**Special Standard
PUD Zoning District**

Project Name: Villages at Sterling Ranch

PCD File No.: PUDSP-226

PRIVATE ROAD (30' WIDE TRACT)

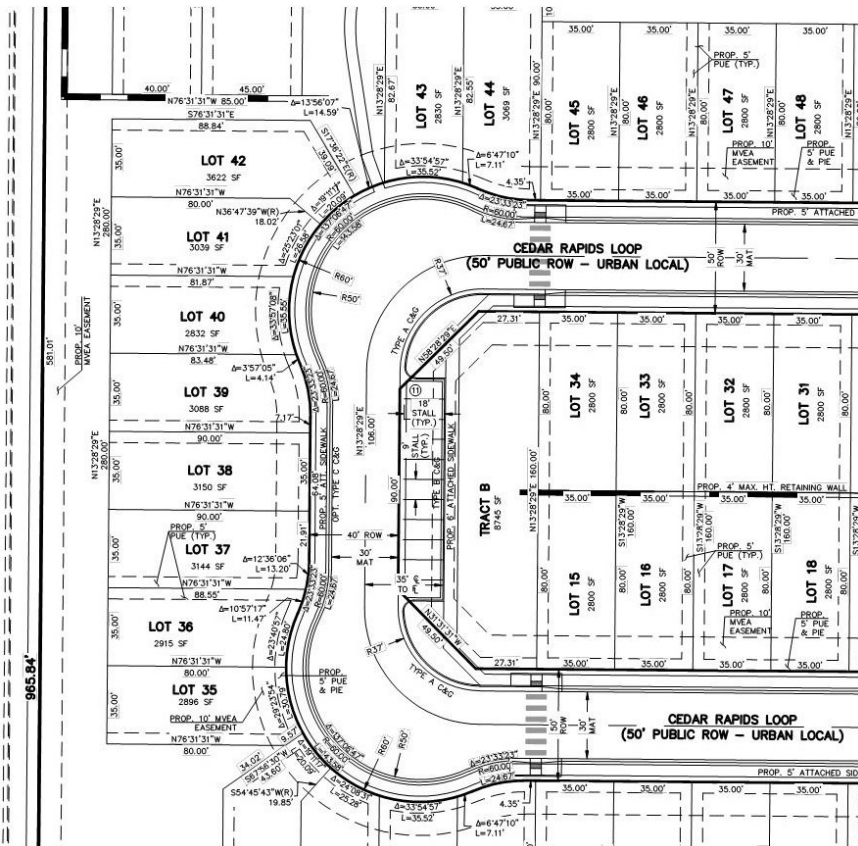
- LDC 8.4.4 (E)(3)**
Reason: **Private roads to meet County standards**
Private roads functioning as an alley cannot meet all County public road standards, thus, the following represent the private road standards:
Revise this one to reference low volume road standard and section is deviating from it.

3. LDC 6.2.5.C.3(g) Special Standards:

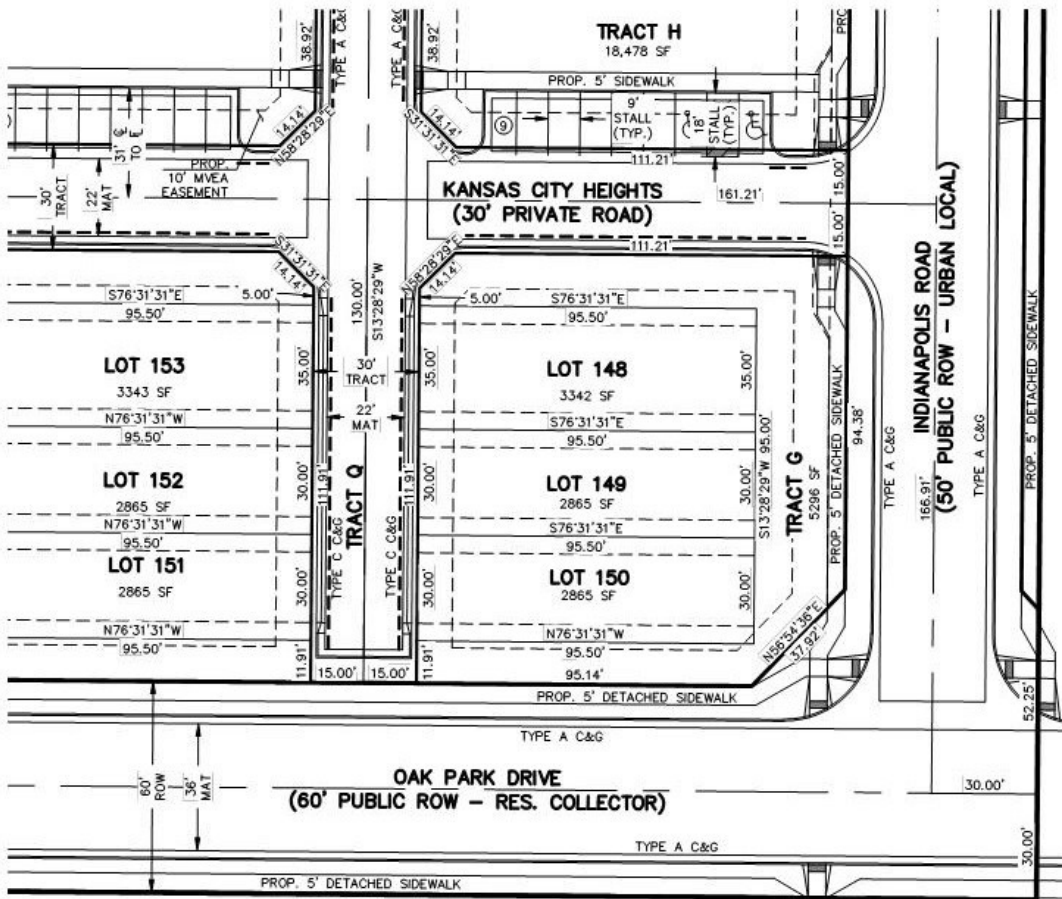
Revise this one to be a deviation to standard road section, ROW width.

(Just change section and title, I think the actual justification & exhibit are fine)
